This Addendum forms part of the Bid Documents and amends the Bid Documents as described below.

END OF ARCHITECTURAL ADDENDUM NO. 2

Project: Kedron East Catholic Elementary School

This Addendum forms part of the Contract Documents and amends the original Drawings, Specifications, Schedules and Details.

2 .5 **Drawing 5/A6.4**

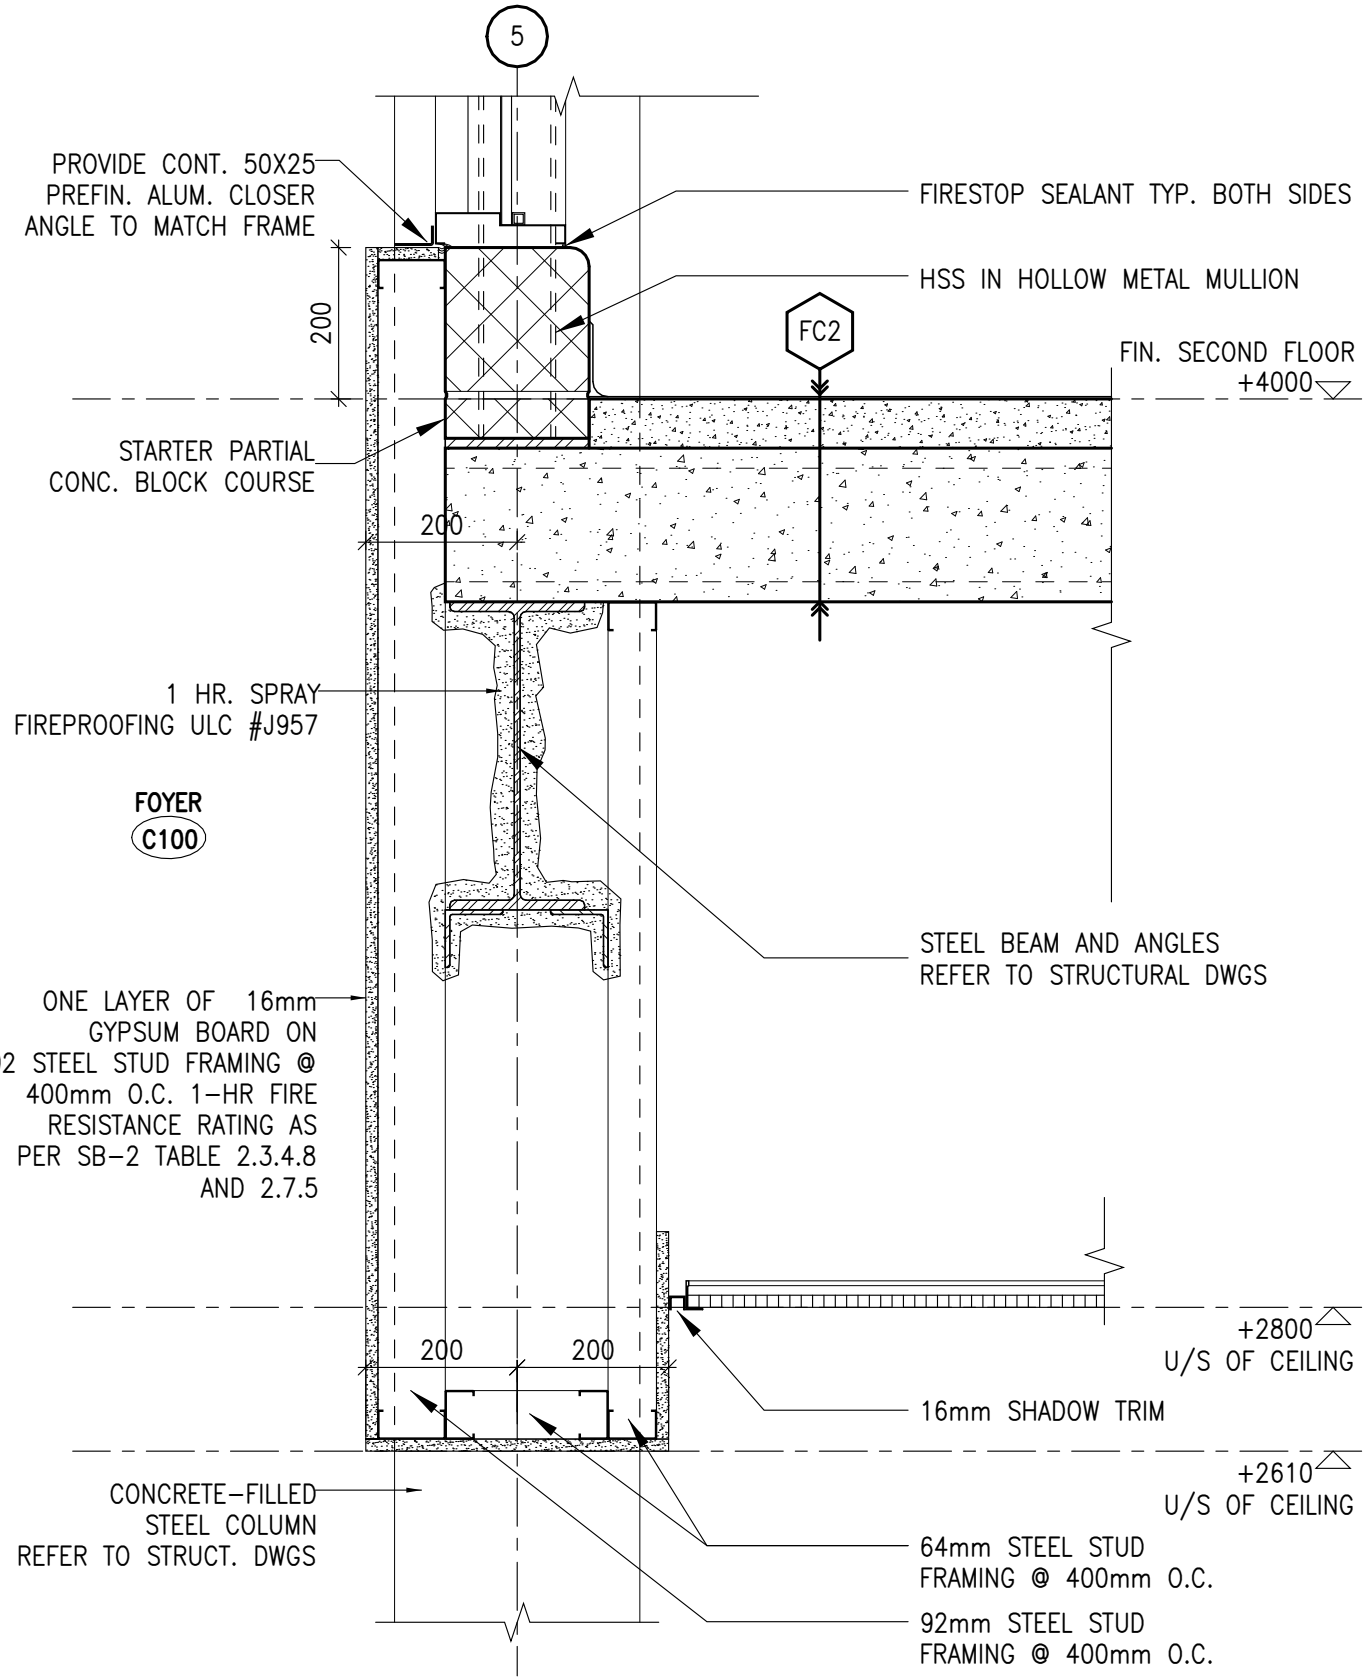
.1 Change acoustic panel note to "610 x 1220mm Cementitious Acoustic Panels (P2) (2 Panels Tall, Trimmed To Suit Height), Cover Extent of CMU".

KEDRON EAST CATHOLIC ELEMENTARY SCHOOL DURHAM CATHOLIC DISTRICT SCHOOL BOARD Fire Rated Hollow Metal Screen Sill at Foyer	SCALE: 1 : 10	DWG NO. D242 REV. 1
MOFFET & DUNCAN ARCHITECTS INC. 5052 DUNDAS ST. WEST, TORONTO, ONT. M9A 1B9 TELEPHONE: (416)-239-2775	JOB #: 2402

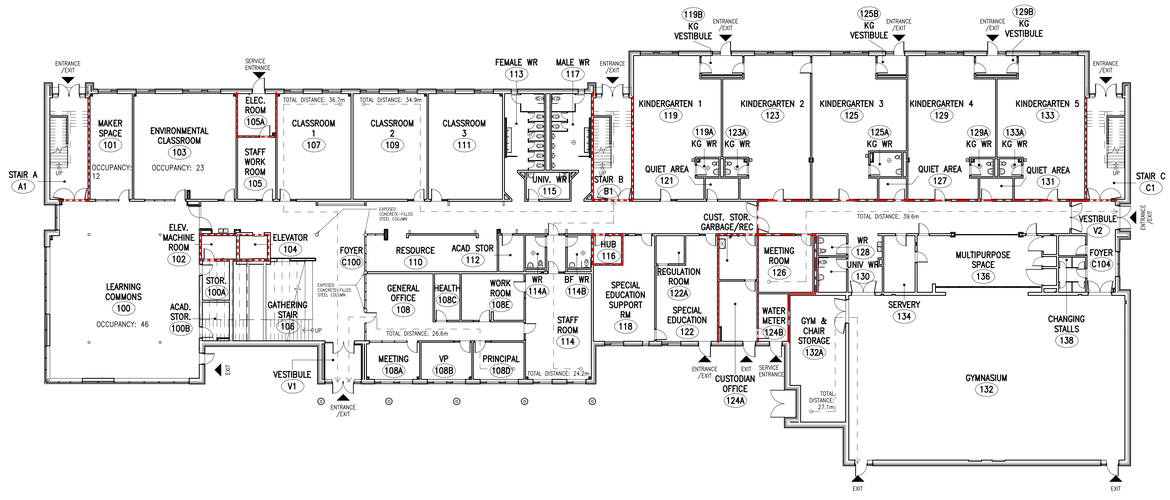
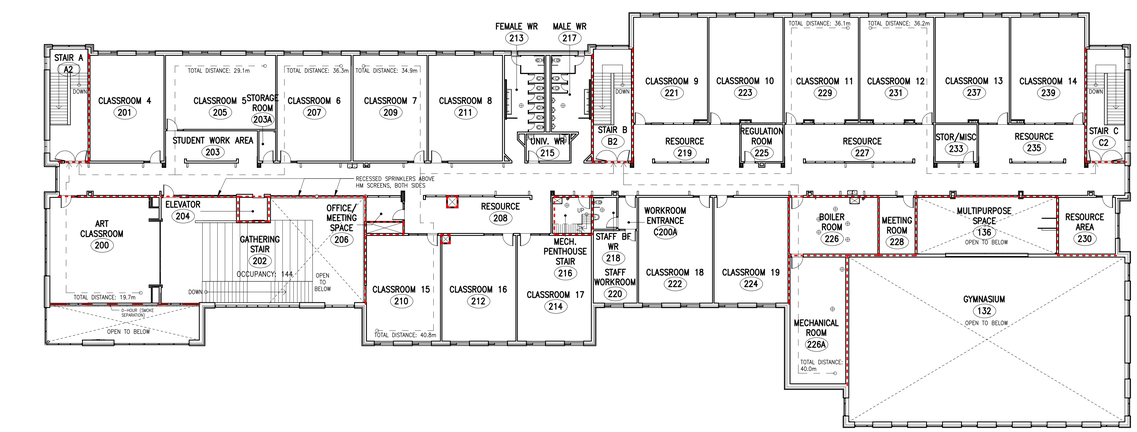
.1 Spray fireproof beam, reduce gyp. layers from 2 to 1, see attached revised detail D242.

DRAWING: GROUND & SECOND FLOOR PLANS – FIRE SEPARATIONS AND OBC MATRIX

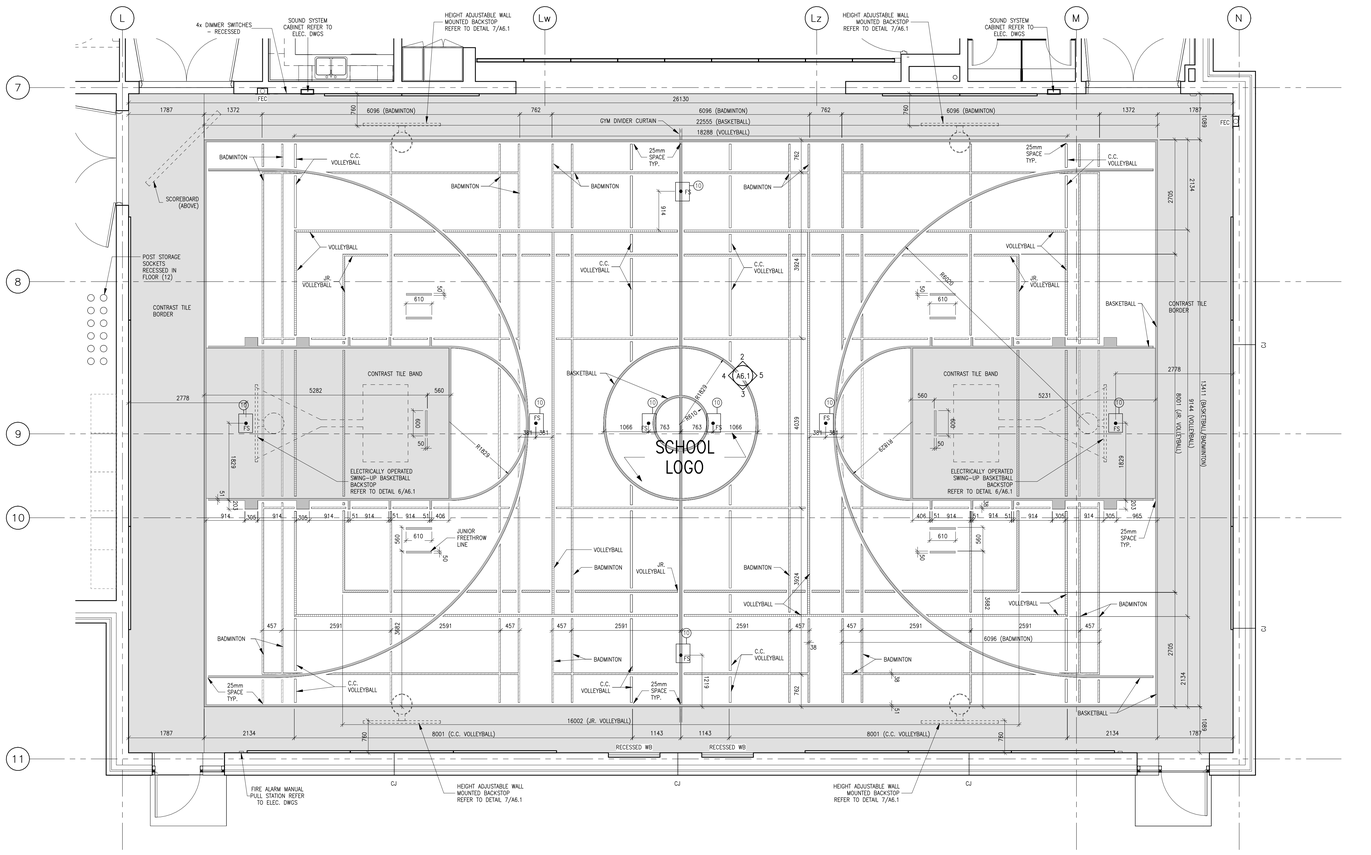
.1 For the "Floor/Beam/Column Fire Ratings" Legend, remove section for "Beams (Gypsum Clad)", as indicated on A1.5 attached in this Addendum.

.2 For the same legend, change the UL Design No. Of "Beams (Spray Fireproofing)" to ULC J957", as indicated on A1.5 attached in this Addendum.

1 A6.1 GYMNASIUM – ENLARGED PLAN
1 : 50

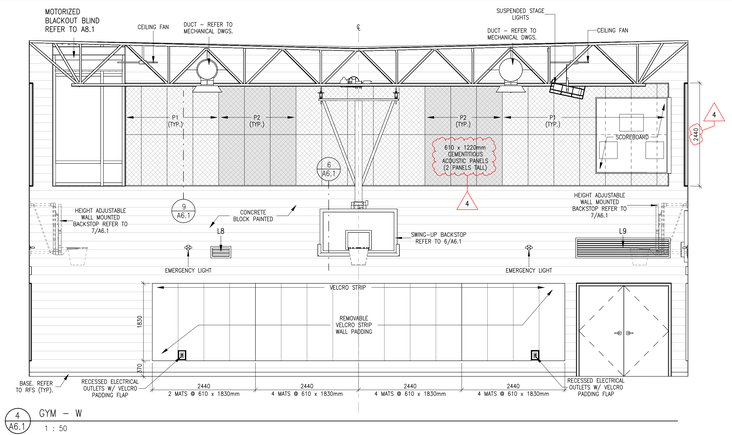
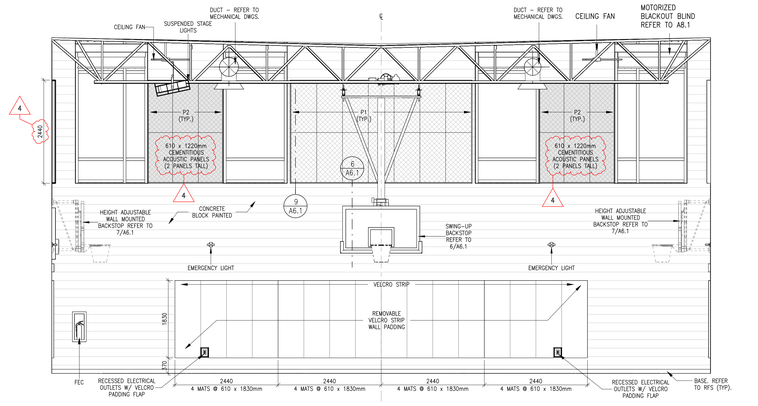
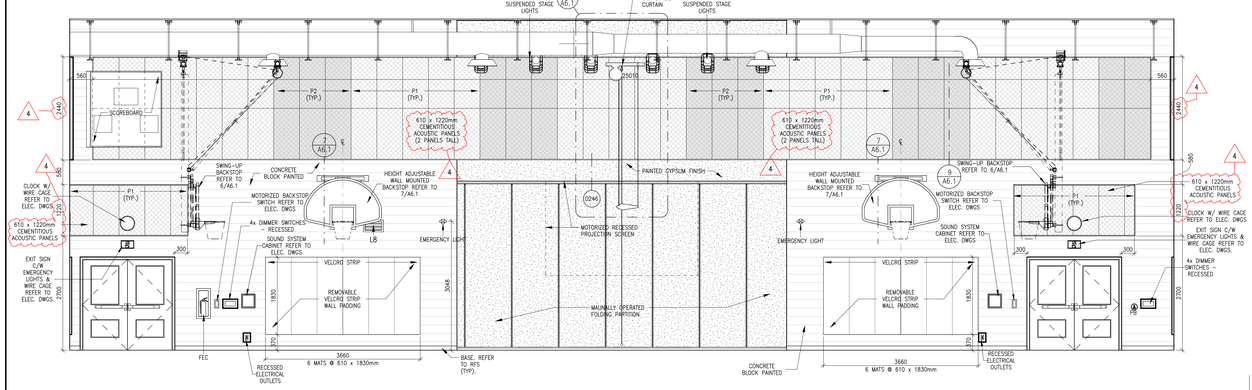
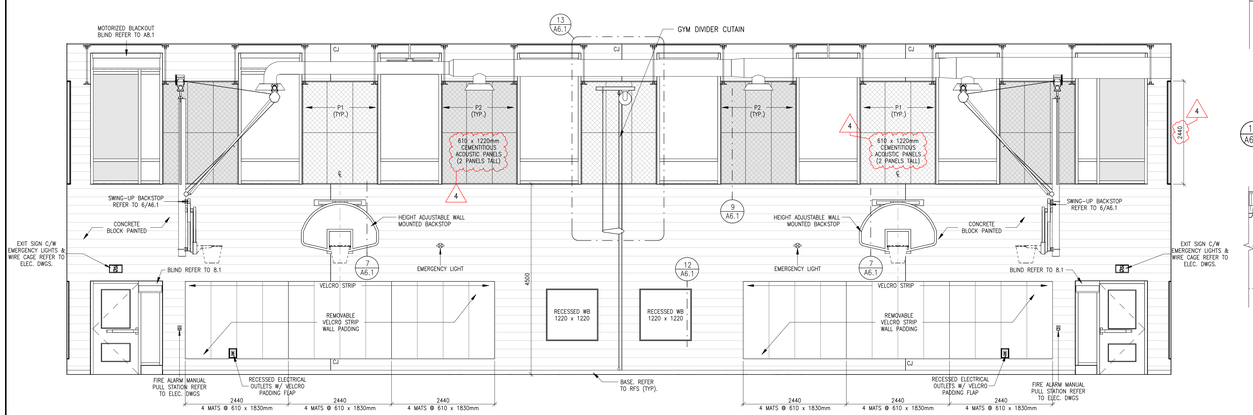
.1 Change acoustic panel note to "610 x 1220mm Cementitious Acoustic Panels (2 Panels Tall)", and overall height of acoustic wall to 2440mm, as indicated on A6.1 attached in this Addendum.

22 A7.2 TOP OF PENTHOUSE STAIR OPENING DETAIL
1 : 10

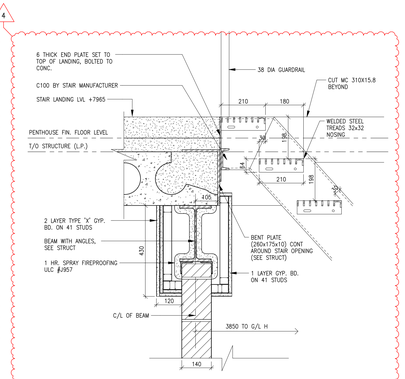
.1 Add spray fireproofing to beams, reduce layers of gypsum from 2 to 1 (except where there is a fire separation), as indicated on A7.2 attached in this Addendum.

Drawing PD1, Rev. #1 (Drawing Issued)

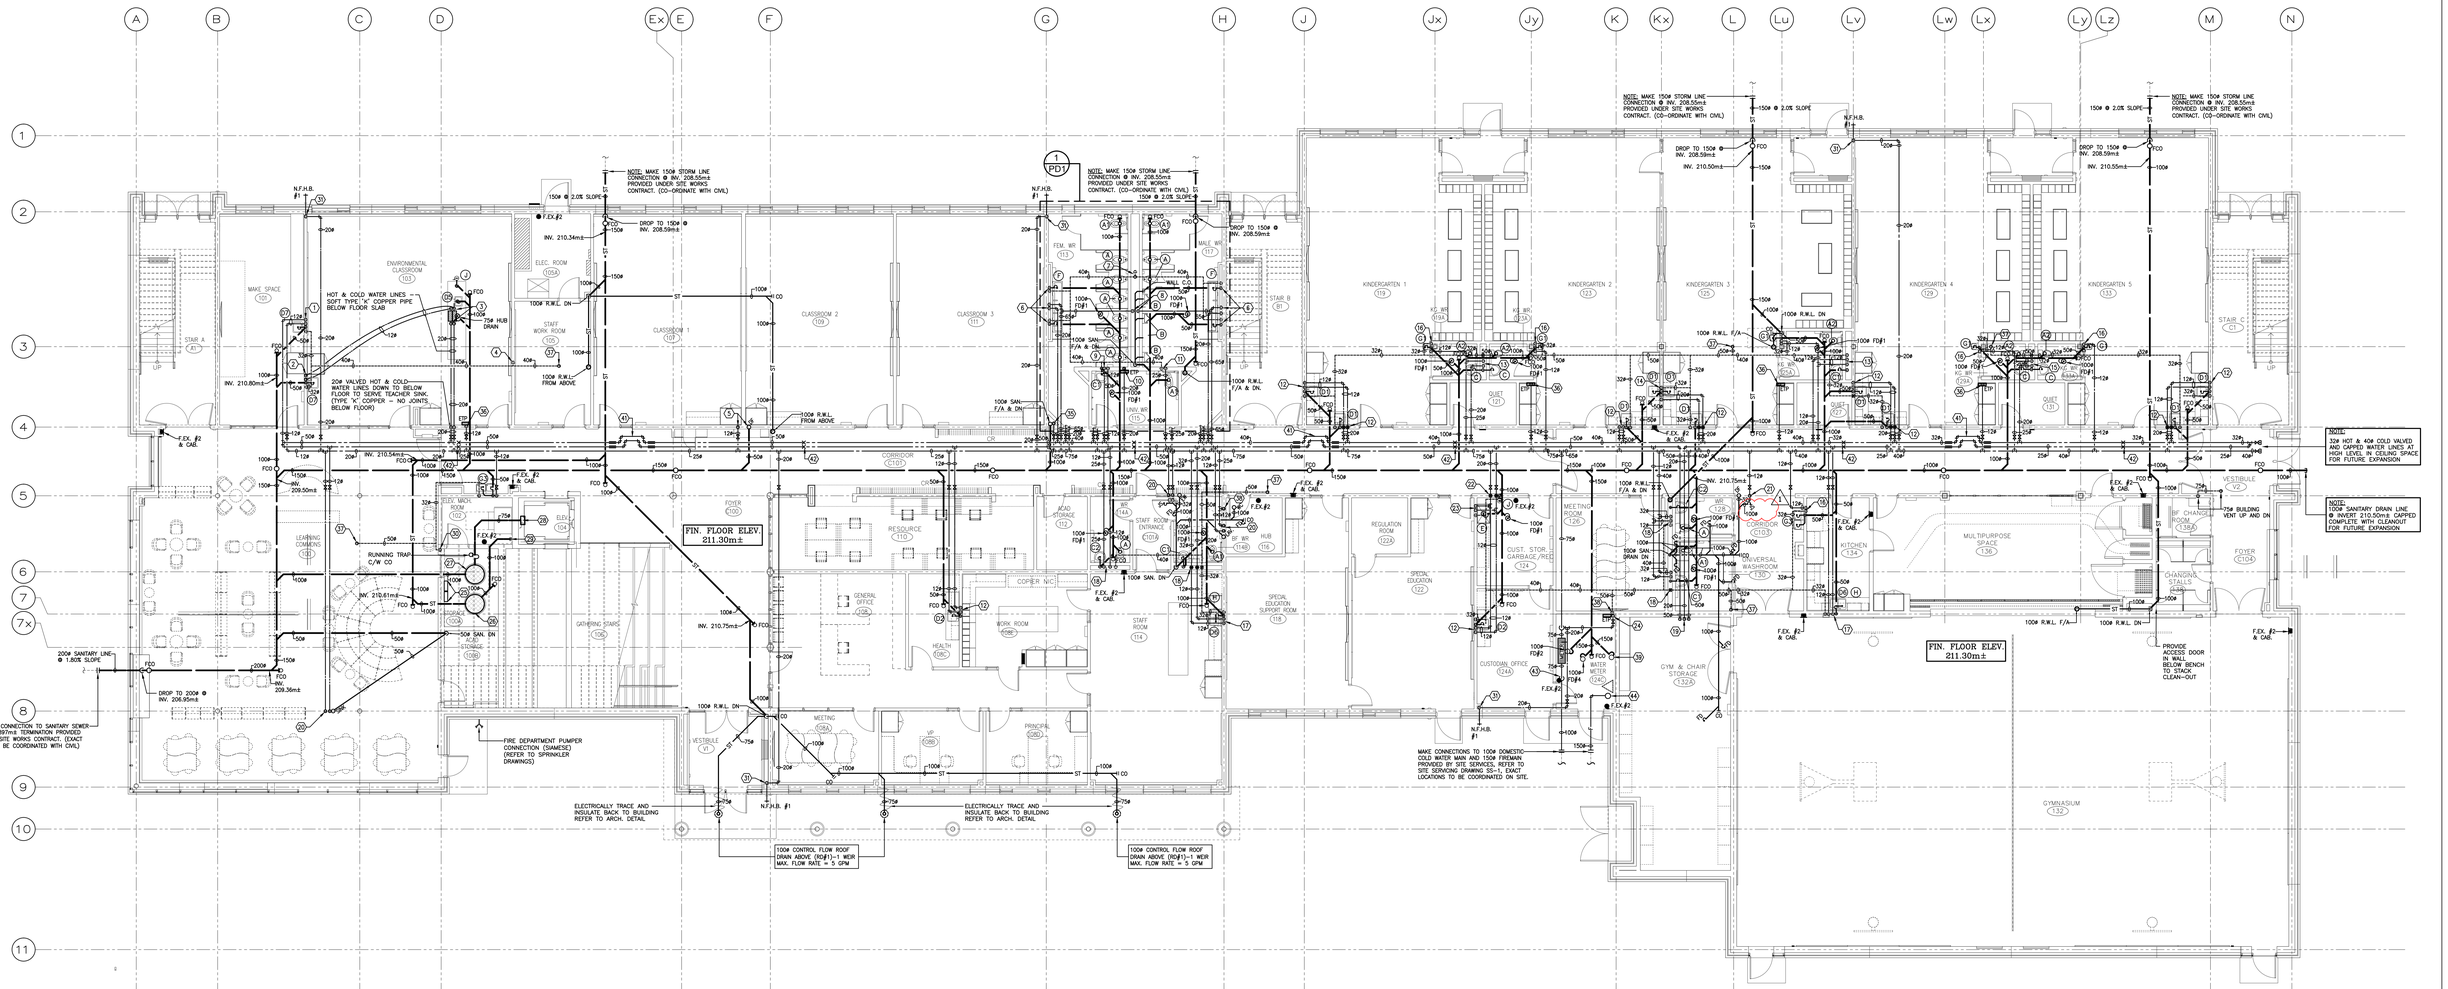
1. Relocated the Mop Sink drain as shown on the drawing.

1 PD2 PLUMBING AND DRAINAGE - SECOND FLOOR PLAN

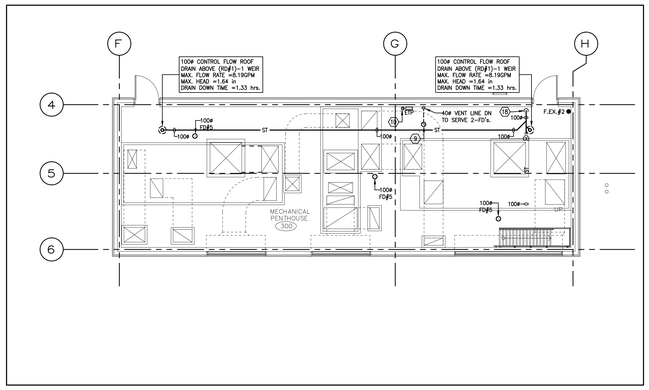
.1 In Boiler Room 226, move the mop sink to the left side of the eyewash station, 250mm away from edge of the eyewash. See Mechanical Addendum M2 for detailed plumbing changes.

2. Relocated the Mop Sink in Boiler Room 226 as shown on the drawing.
